**Solano Concrete Long-term Off-channel
Mining Permit
Habitat Restoration Plan**

ADDENDUM

FIGURE 3
 Habitat Management Lands
 Solano Concrete

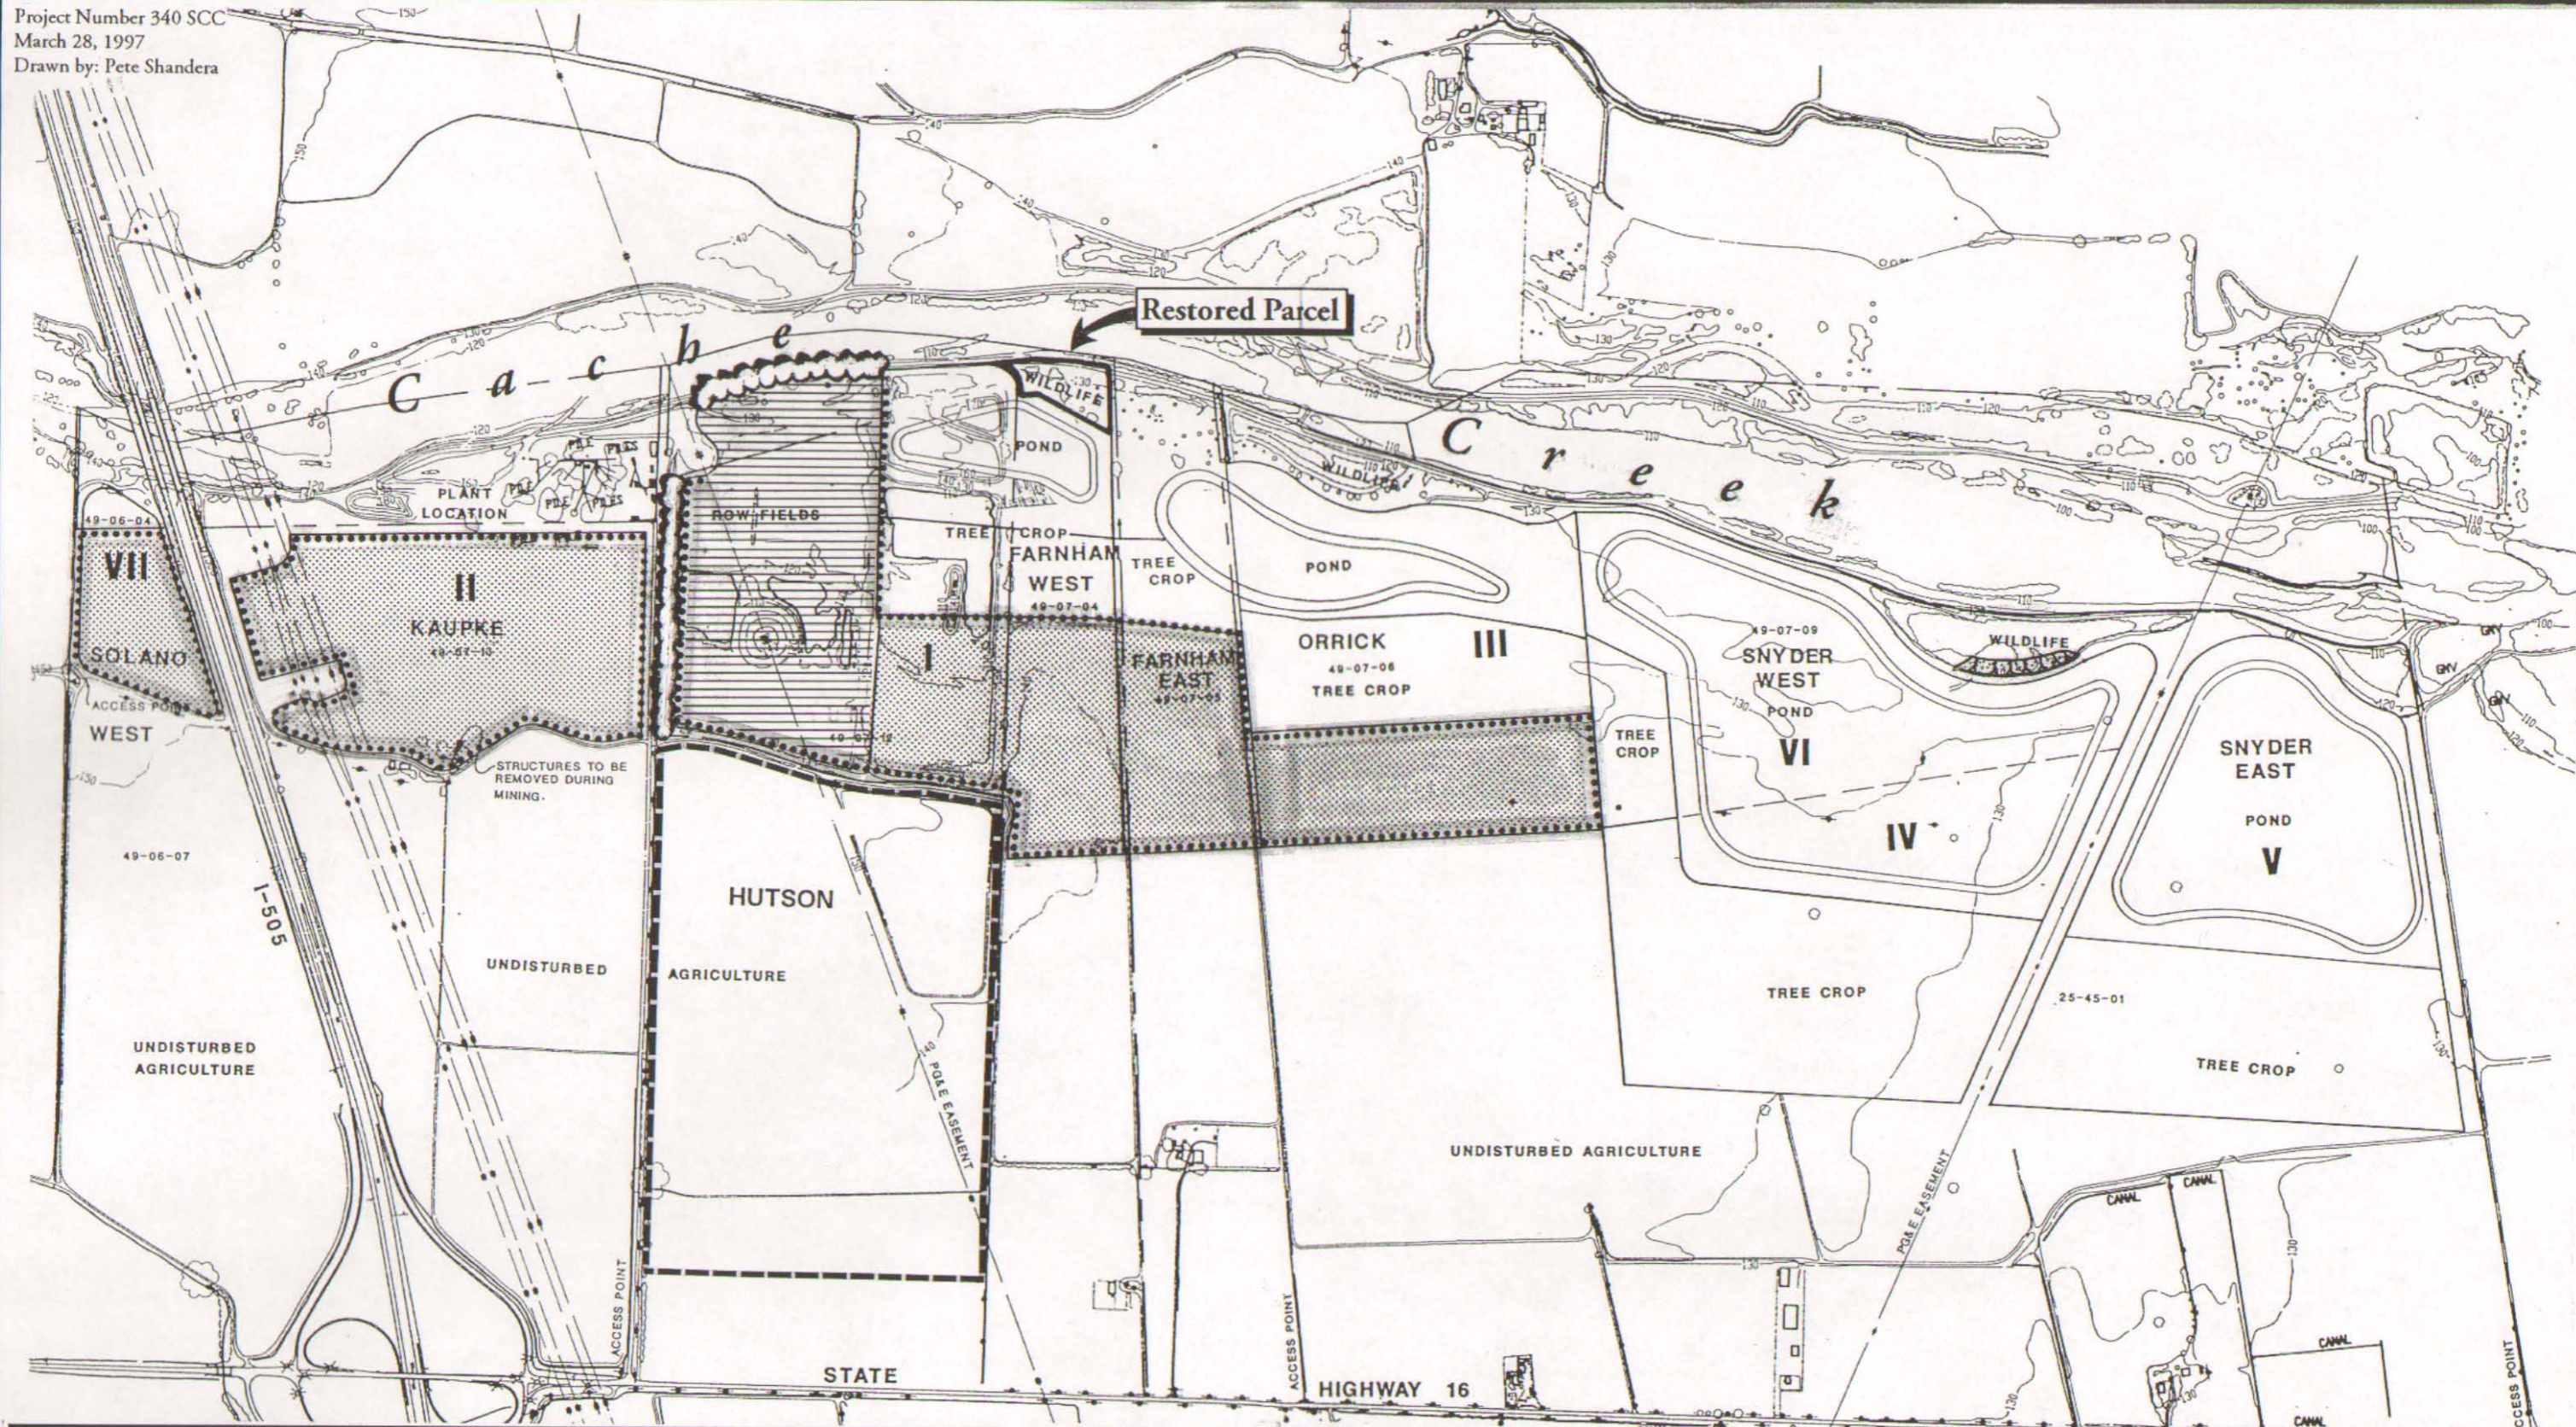
As shown in the attached revised Figure 8, hedgerow plantings have been added and will be provided around the northern and western edges of the Hutson parcel.

These plantings will be provided in Phase 1 as required by the condition. As noted in the HRP, the 3:1 slopes will be planted with a diverse mix of oak woodland and native grassland species. Valley oaks will be dominant in this area at a density of approximately 6 per acre.

The HRP had proposed establishing seasonal marsh in the mining-related depression north of the Snyder East parcel in the phase 6 area. The conditions of approval require that the existing riparian woodland in this area be retained and enhanced, rather than construction of seasonal marsh. This basin has several dense clusters of willows and cottonwood. These will be expanded with the same species mix and

densities noted in the HRP for riparian woodland areas and the upper slopes of the basin planted with the species mix and densities noted for the oak woodland habitats in the HRP. These plantings shall be located so as to not interfere with bank swallow habitat (see condition 61 below).

Condition 61 requires that the HRP be revised to provide bank swallow habitat. Bank swallow nesting in the sheer face of the active mining portion of the Hutson

parcel was observed in 1991, 1992, and 1993. The swallows have obviously become acclimatized to the noise and other effects of mining (acclimatization to periodic and frequent machine noises is a common feature in many birds).

The project proponent will restore to the extent necessary the bluffs above the mining-related riparian habitat in the northern portion of the Snyder East parcel in the Phase 6 area. This site is already suitable habitat with near-vertical bluffs. Bank swallows have recently begun nesting in these bluffs and no further enhancement actions appear necessary aside from preservation of this area.
